Re: OAK PARK VILLAGE MHPD
4th INSUFFICIENCY COMMENT LETTER
DCI2021-00019

OAK PARK VILLAGE MHPD

Schedule of Deviations and Written Justification

MASTER CONCEPT PLAN

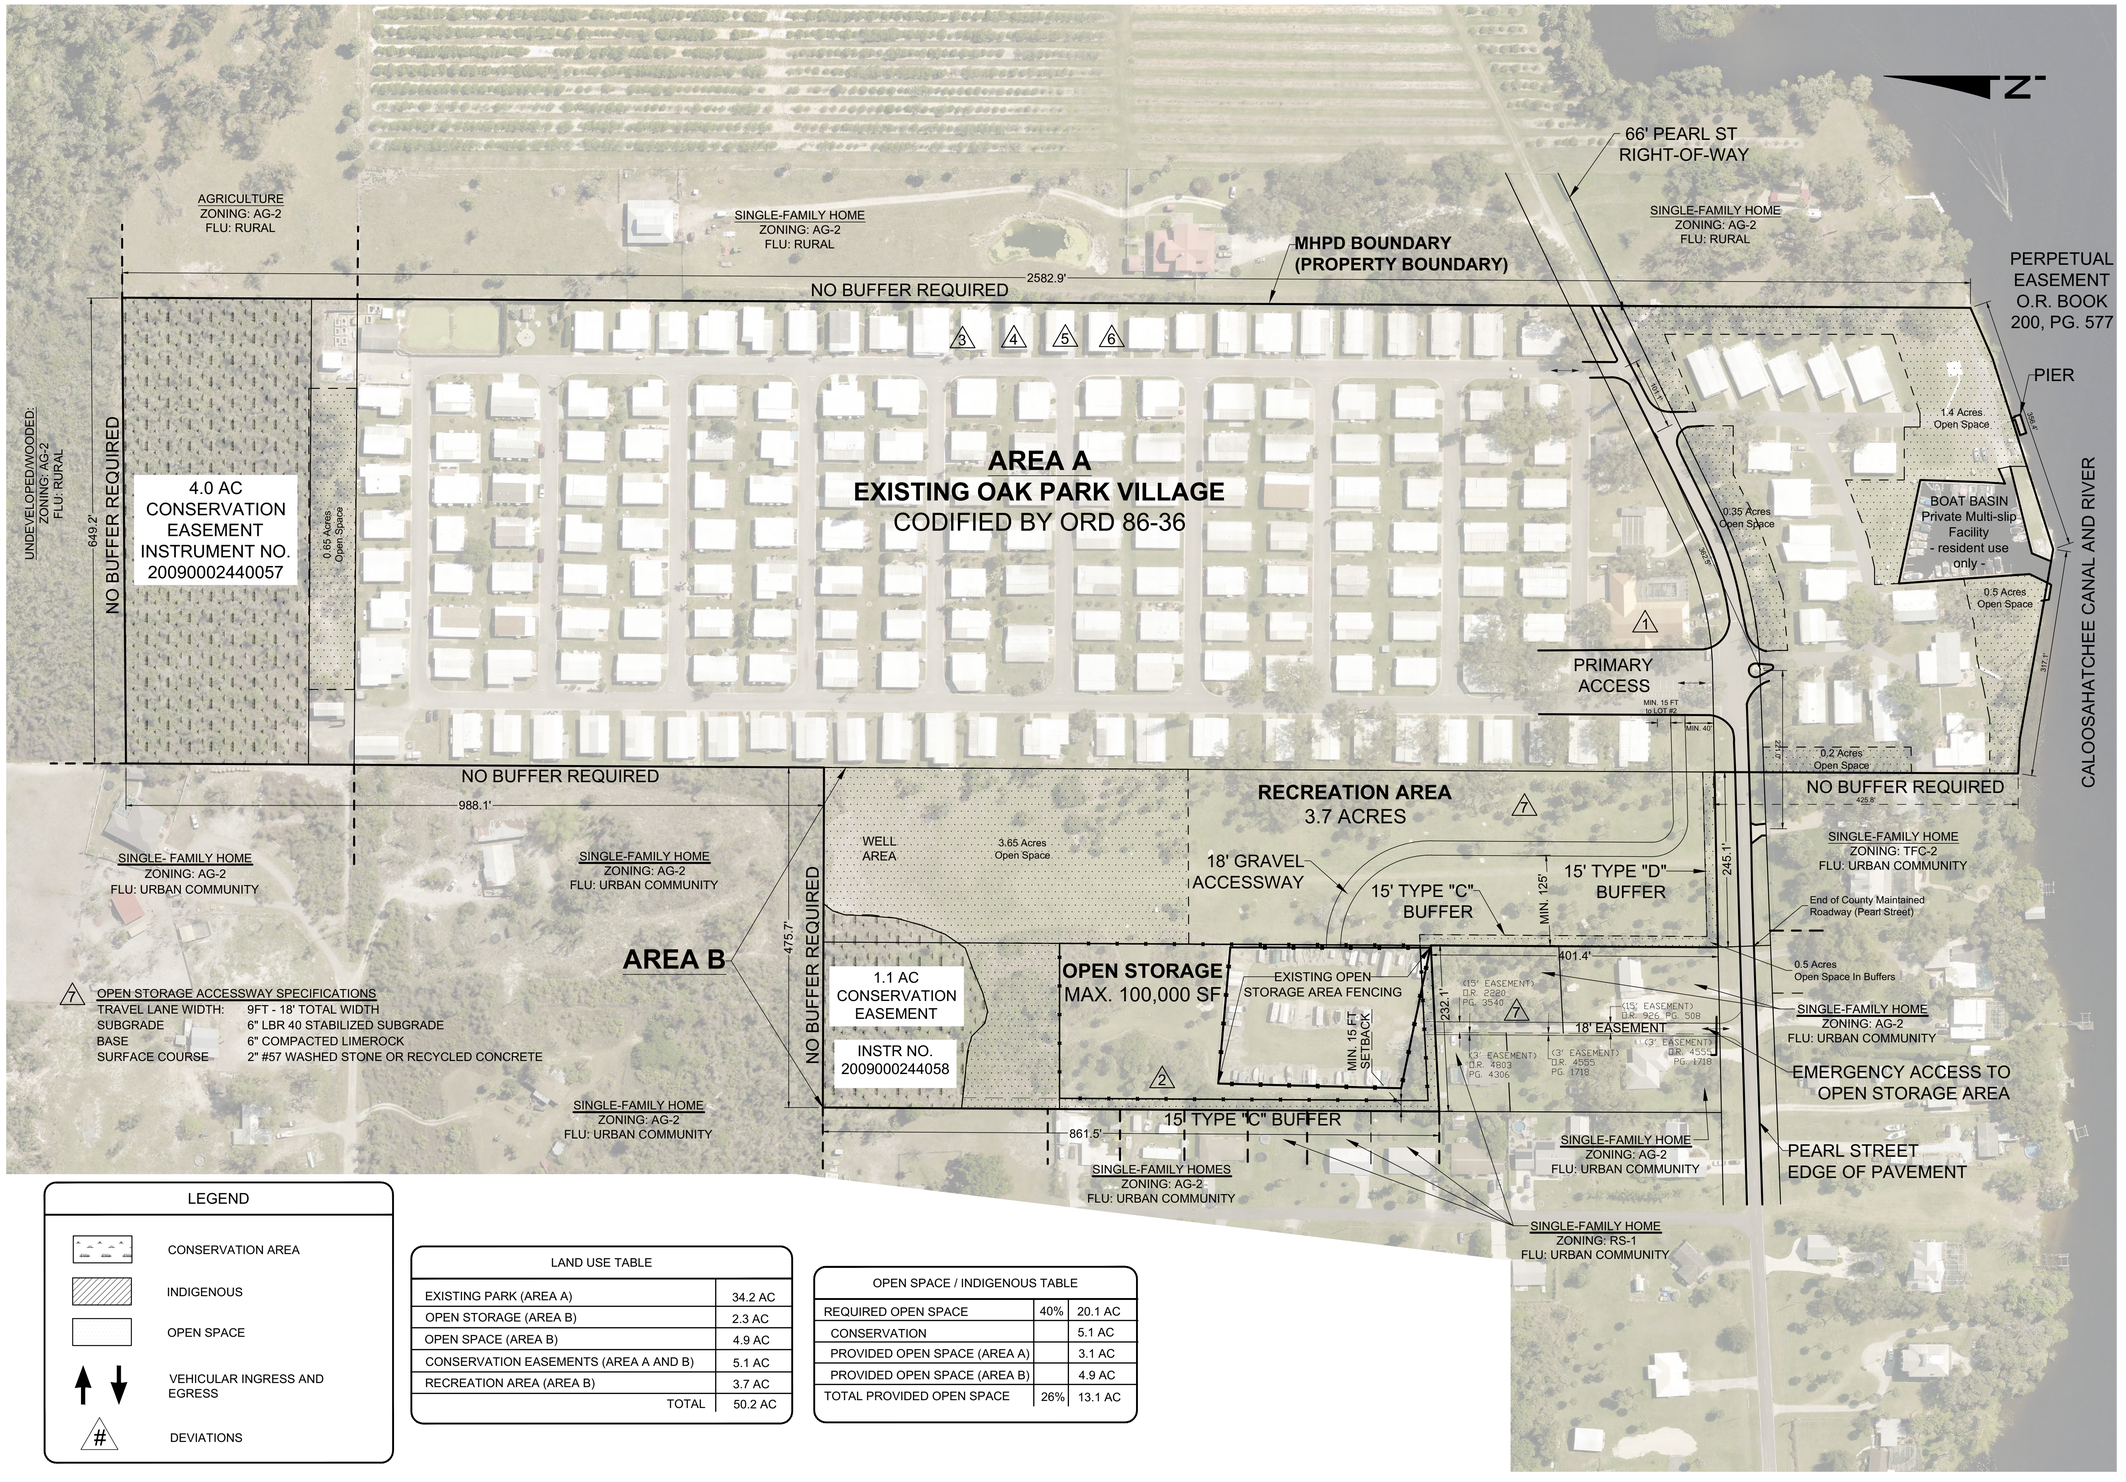
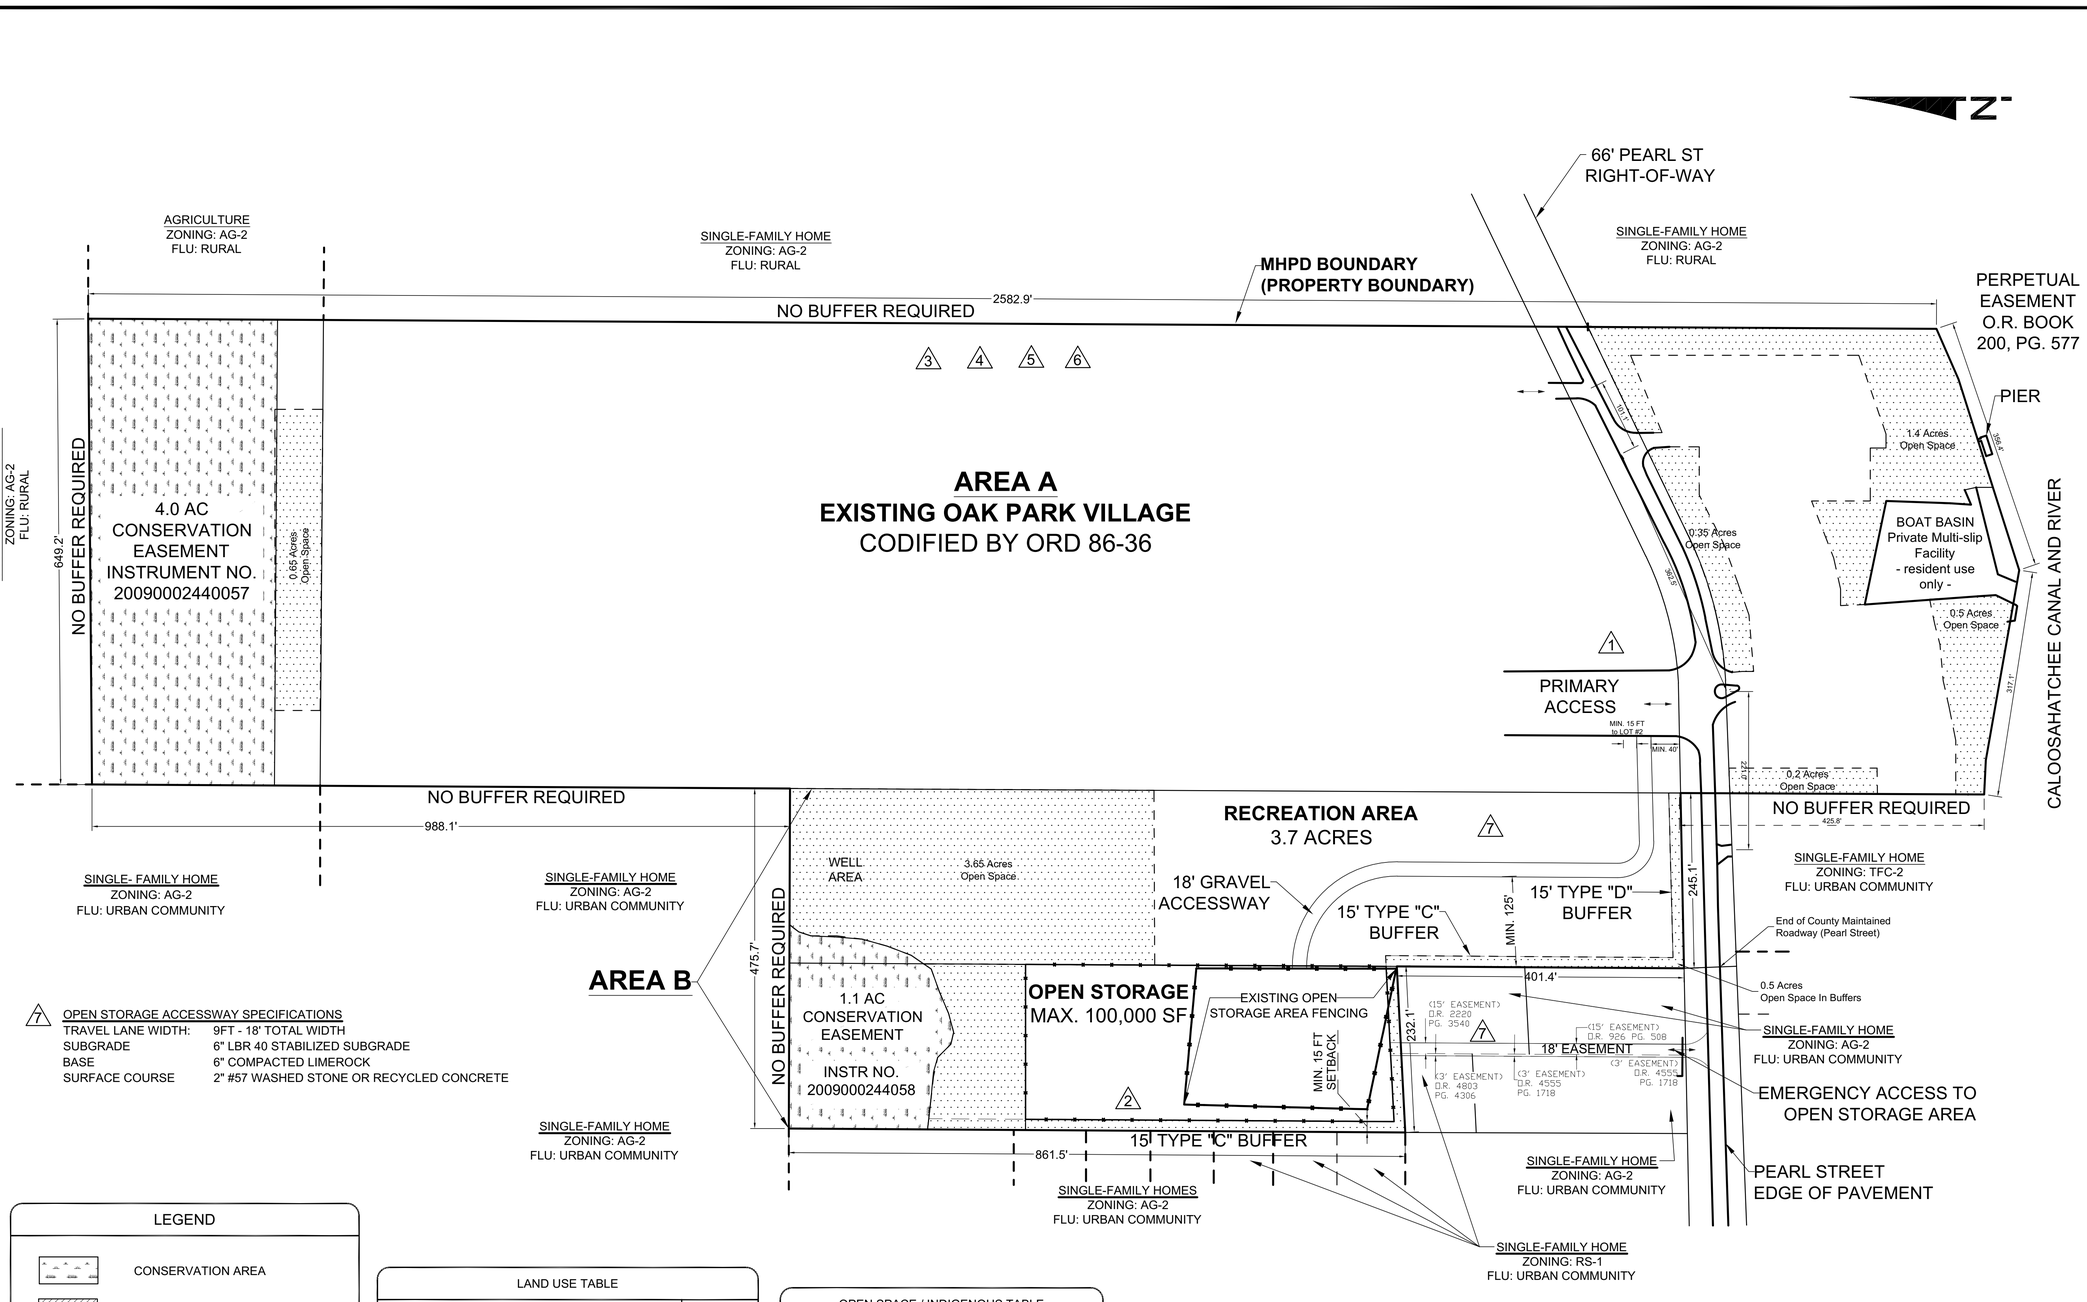
1. The applicant's justification to deviate from the requirements of LDC 10-296 states that the access is "in all functionality a driveway" and that LDC 10-296 "is not appropriate for a residential driveway". Staff agrees that LDC 10-296 is a not appropriate for a residential driveway and in fact 10-296(I)(3) specifically exempts driveways (as defined in chapter 10) from the requirements of LDC 10-296. A "driveway" is defined in LDC 10-1 as a type of access point which provides vehicle access from a street to a single parcel of land containing two or fewer dwelling units in a single structure and from which vehicles may legally enter or leave the street in a forward or backward motion. The access easement does not fit the definition of a driveway as it provides access to more than a single parcel of land as well as a proposed storage area. Furthermore, LDC 10-291 requires development to abut and have access to a public or private street designed, and constructed or improved, to meet the standards in section 10-296 or a deviation from that requirement. Staff does not agree that it "functions as a driveway according to AASHTO and Florida Greenbook". AASHTO, the FDOT - Driveway Information Guide, and the FDOT Access Management Guidebook all define a driveway as "an access constructed with a public R/W (Right-of-Way) connecting a public road with adjacent property." The subject site is not adjacent to a public road and the access easement provides access to two other parcels besides the subject parcel which are not adjacent to a public R/W.

2. The applicant references the use of two-way single lane roads where traffic volumes are limited to 100 vpd but did not provide any traffic generation or support that shows that the existing residences and proposed storage yard will generate less than 100 vpd. Please demonstrate that the existing and proposed development will have less than 100 vpd.

3. How is roadway drainage addressed? The applicant is proposing improvements that will require water quality and quantity treatment per LDC 10-321(a).

RESPONSE: Per meeting with staff and meeting with the Oak Park Village Board the attached MCP shows a revised entrance to the outdoor storage area that is now entirely on property owned by Oak Park Village. This means that the use of the 18' easement as the primary access to the outdoor storage area will discontinue at the time of local development order and will revert to an emergency access only.

The revised entrance fits the Lee County Land Development Code Section 10-296(L)(4) of a privately maintained accessway which is not required to meet the minimum roadway right-

As a low-volume, privately maintained, accessway not requiring to meet 10-296(b), we propose a gravel road with 18' width (9' travel lanes) per 10-296(b), Note (1) that allows, "The right-of-way width to be determined by the Director of Transportation on public roadways and by the Director of Development Services on privately maintained roadways."

The outdoor storage area access is for residents only on private land owned and maintained entirely by Oak Park Village Cooperative. The accessway is entered by turning off Pearl Street to Aloe Street and turning west through the southern part of Lot 1 (1 Aloe Street, STRAP 23-43-27-02-00014.0010). Pearl Street County maintenance ends approximately 400 feet west of the entrance to Oak Park at Aloe Street making this a private roadway.

JUSTIFICATION: Per meeting with staff and meeting with the Oak Park Village Board the attached MCP shows a revised entrance to the outdoor storage area that is now entirely on property owned by Oak Park Village. This means that the use of the 18' easement as the primary access to the outdoor storage area will discontinue at the time of local development order and will revert to an emergency access only.

7 OPEN STORAGE ACCESSWAY SPECIFICATIONS

TRAVEL LANE WIDTH:	9FT - 18' TOTAL WIDTH
SUBGRADE	6" LBR 40 STABILIZED SUBGRADE
BASE	6" COMPACTED LIMEROCK
SURFACE COURSE	2" #57 WASHED STONE OR RECYCLED CONCRETE
